STAFF RECOMMENDATION
2811 Belmont Boulevard
May 15, 2019

Application: New Construction—Addition and Detached Accessory Dwelling Unit
District: Belmont-Hillsboro Neighborhood Conservation Zoning Overlay
Council District: 18
Zoning: R8
Map and Parcel Number: 11704026300
Applicant: Martin Wieck, Nine12 Architects
Project Lead: Melissa Baldock, melissa.baldock@nashville.gov

Figure 1. 2811 Belmont Boulevard

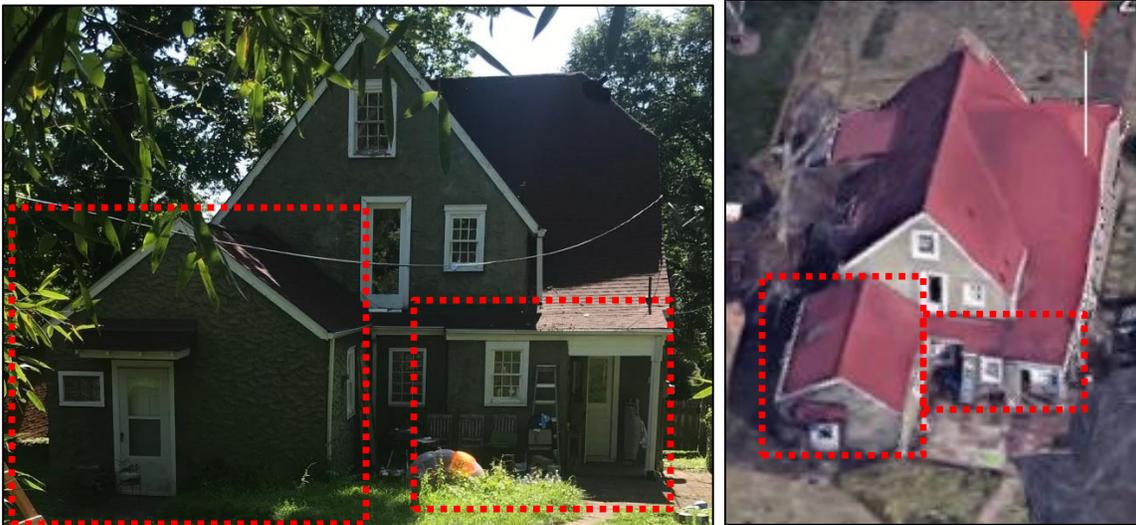
Background: The house at 2811 Belmont Boulevard was constructed c. 1926 (Figure 1). It is constructed of stone with stucco detailing, and it contributes to the historic character of the Belmont-Hillsboro Neighborhood Conservation Zoning Overlay.

Figures 2 & 3 show the area of the rear that is proposed to be demolished.

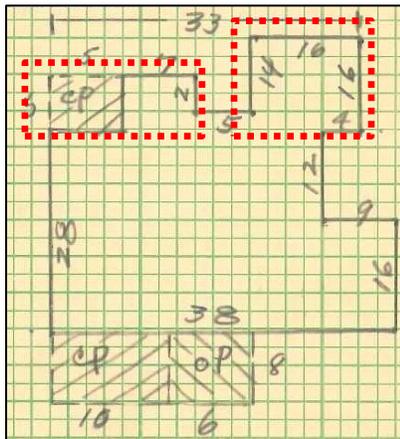
Demolition: The applicant intends to demolish some parts of the rear of the house. Staff finds that these portions of the rear of the house do not contribute to the historic character of the historic house. It is likely that the shed roof portion of the rear that is to be demolished was part of the original house, as it appears on the Sanborn maps from the 1950s. However, staff finds that its roof form, materials, small size, and location all the way at the rear of the house do not contribute to the historic house’s historic or architectural character. The gabled portion of the rear was constructed between 1957 and 1968, as it does not appear on the 1957 Sanborn Map but does appear in the Property Assessor’s office c. 1968 file for the house. Staff finds that its date of construction and materials do not contribute to the historic character of the house. Staff therefore finds that the demolition of the rear portion of the house meet the design guidelines.

Figure 4 (left) is the 1957 Sanborn map that shows the sloped roof portion of the rear, but not the one-story gable portion. Figure 5 (right) is a c. 1968 footprint of the house from the Property Assessor’s office, showing the rear gabled addition.

Staff finds that the proposed partial demolition meets Section V.B.2 for appropriate demolition and does not meet section V.B.1 for inappropriate demolition.

Figure 6 (left) is the c. 1968 Sanborn map, showing the small second story window opening on the front. Figure 7 (right) is the applicant's proposal to increase the size of the window openings on the front façade.

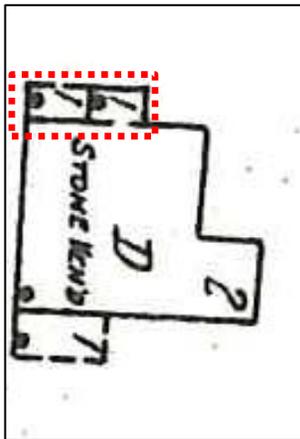
The applicant also intends to alter a window opening on the front façade, which staff considers to be partial demolition. On the second story, front façade, there is an area that is largely stuccoed with a small window opening (See Figure 1). The c. 1968 Property Assessor photo shows a similar condition to what is existing today. However, it is known that the house was altered and expanded between 1957 and 1968, and it is not known if this front window is original to the house. Typically, in a second story projection like this, there would have been more window openings. Because it is not clear if the existing window opening in this area is original to the house, and because it is more typical to have more and larger window openings than what is currently there, staff finds that the demolition of the wall in order to have larger window openings is appropriate and meets the design guidelines.
